February 1, 2018

ND-18-0106
10 CFR 50.90
10 CFR 52.63

Southern Nuclear Operating Company
Vogtle Electric Generating Plant Units 3 and 4
Request for License Amendment and Exemption:
Changes to the Building Gap between the Nuclear Island and Adjacent Buildings (LAR-18-002)

Figure 1: Illustrative Sketch of the Nuclear Island and Annex/Turbine Buildings Displacements during an SSE

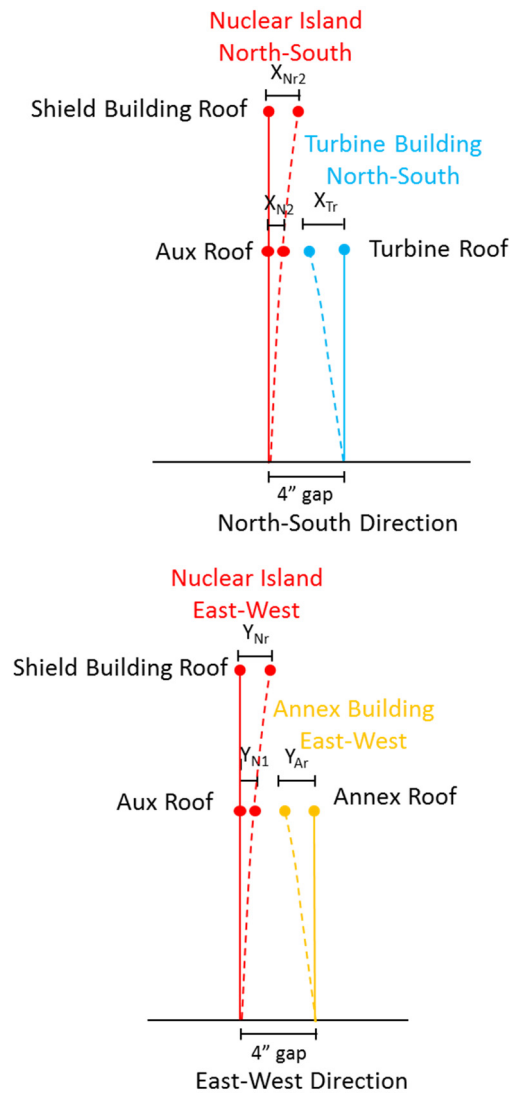
The current licensing basis, including COL Appendix C ITAAC No. 3.3.00.13, UFSAR Appendix 2.5E Section 5.2 and UFSAR Subsections 3.7.2.8.1, 3.7.2.8.2 and 3.8.5.1, defines a minimum 4 inch gap above grade between the nuclear island and adjoining buildings. The purpose of the gap is to avoid contact between the nuclear island and seismic Category II structures (annex building/turbine building) when the buildings deflect during an SSE event. The seismic response analyses, including soil-structure interaction between the nuclear island and the adjoining building, are performed using the System for Analysis of Soil-Structure Interaction (SASSI) program. The maximum relative seismic displacement is established from the 2D SASSI analyses, as specified in UFSAR 3.7.2.8.4. The SASSI models consist of soil profiles and properties, basemat models and structure models, which include the coupled auxiliary and shield building stick model, containment internal structures stick model and steel containment vessel stick model. The SASSI models also include the annex building East-West and the turbine building first bay as stick models. Previous design changes are incorporated into the latest AP1000 generic 2D SASSI analysis, including changes to the nuclear island (e.g., polar crane mass change) and adjacent buildings (e.g., change of structures of turbine building first bay). The latest AP1000 generic 2D SASSI analyses show that the maximum relative seismic displacement between the annex building and the nuclear island is 0.95 inches, and between the turbine building and the nuclear island is 1.04 inches, which are both less than the 2 inch maximum relative seismic displacement requirement. The illustrative sketch of building deflections under an SSE is shown in Figure 1 below. Table 1 is also provided to summarize the current and proposed licensing requirements, and the values in the calculations which support the proposed licensing change.

Licensing Basis (LB)		Current LB Requirements	Proposed LB Requirements	Calculations Supporting Proposed LB Requirements
T1	Table 3.3-6	Turbine Building & Annex Building: 4" min gap	Turbine Building & Annex Building: 3" min gap	N/A
T2	Subsection 3.7.2.8.1	Annex Building: $Y_{Ar} \leq 1.6"$	Annex Building: $Y_{Ar} \leq 1.6"$	The supporting calculation demonstrates $Y_{N1} + Y_{Ar} = 0.95"$
T2	Subsection 3.8.5.1	Annex Building: $Y_{N1} + Y_{Ar} \leq 3"$ Turbine Building: $X_{N2} + X_{Tr} \leq 3"$	Annex Building: $Y_{N1} + Y_{Ar} \leq 2"$ Turbine Building: $X_{N2} + X_{Tr} \leq 2"$	The supporting calculation demonstrates $Y_{N1} + Y_{Ar} = 0.95"$ The supporting calculation demonstrates $X_{N2} + X_{Tr} = 1.04"$
		Annex Building: $4" - (Y_{N1} + Y_{Ar}) \geq 1"$ Turbine Building: $4" - (X_{N2} + X_{Tr}) \geq 1"$	Annex Building: $3" - (Y_{N1} + Y_{Ar}) \geq 1"$ Turbine Building: $3" - (X_{N2} + X_{Tr}) \geq 1"$	N/A
